**FINAL REPORT 10CFR PART 21
REPORTING OF DEFECTS AND NON-COMPLIANCE**

PREPARED BY:	<u>Ed Grandusky</u>	File No.:	<u>F-36674 A/B/C/D</u>
TITLE:	<u>Nuclear Product Engr.</u>	Serial No.:	<u>T-36674 A/B/C/D</u>
DATED:	<u>8/24/95</u>	Type:	<u>GS-2N</u>
TIME:	<u>4:30</u> <u>AM/PM</u>	Ref.:	<u>N/A</u>
PART NAME:	<u>Nut, Lock-Flexloc Reg Hgt.</u>	D-R Part No.:	<u>75233A06</u>
		D-R Dwg. No.:	<u>75233A</u>
		Rev. Level:	<u>D</u>

TYPICAL ASSEMBLY

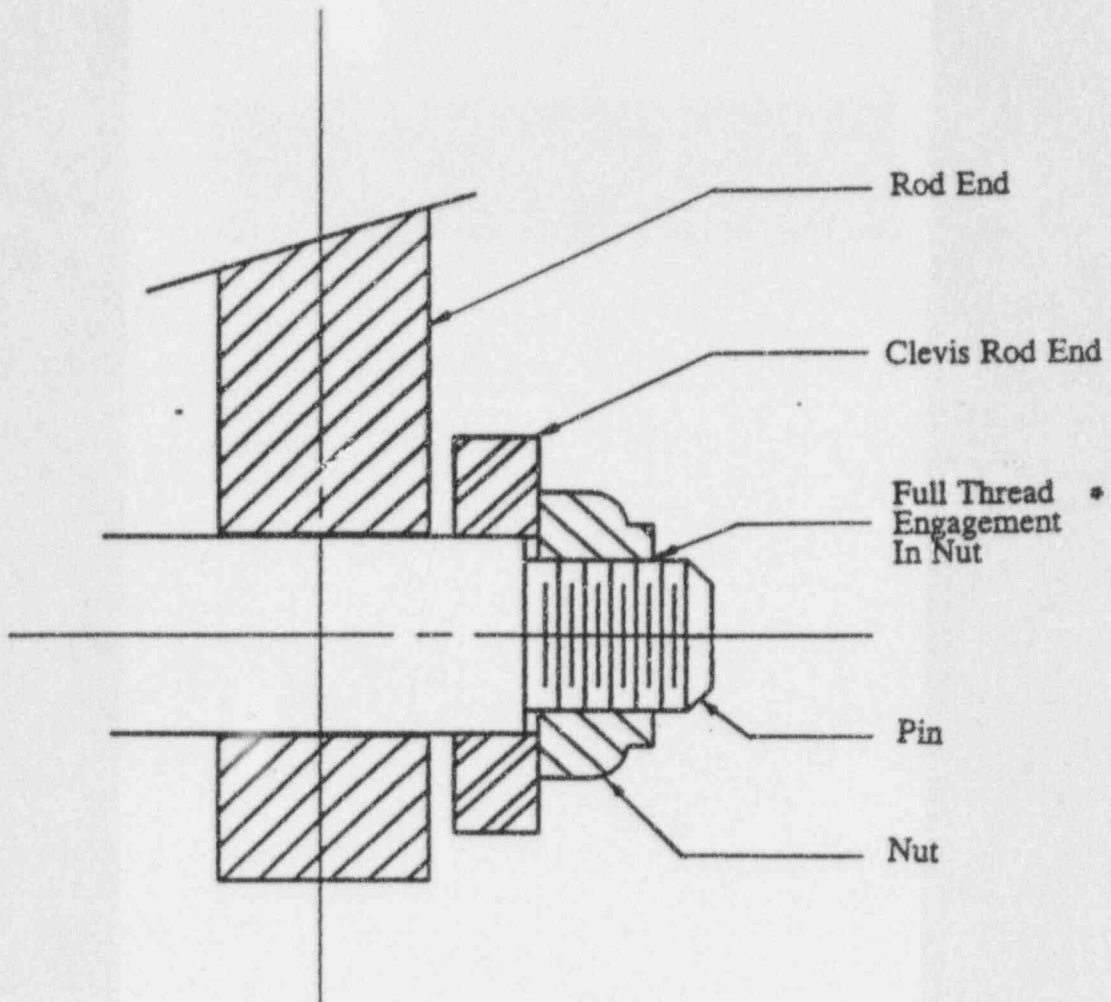
Regular locknut, SPS-Flexloc no. 21FA616, D-R p/n 75233A06 may be installed on governor valve linkages where the thinner locknut, SPS-Flexloc no. 21FK616, D-R p/n 75232A06 is required.

Inadequate thread engagement in the thicker locknut may result in linkage separation if the nut loosens from vibration and spins off. This will result in loss of turbine control capability.

* All threads in the locknut must be engaged by the threads on the pin. Amount of exposed threads will vary with application.

All applications of thick nut p/n 75233A06 on control linkages will be reviewed to insure there application is correct.

Inspect all applications of locknuts on the control linkage for full thread engagement in locknut.
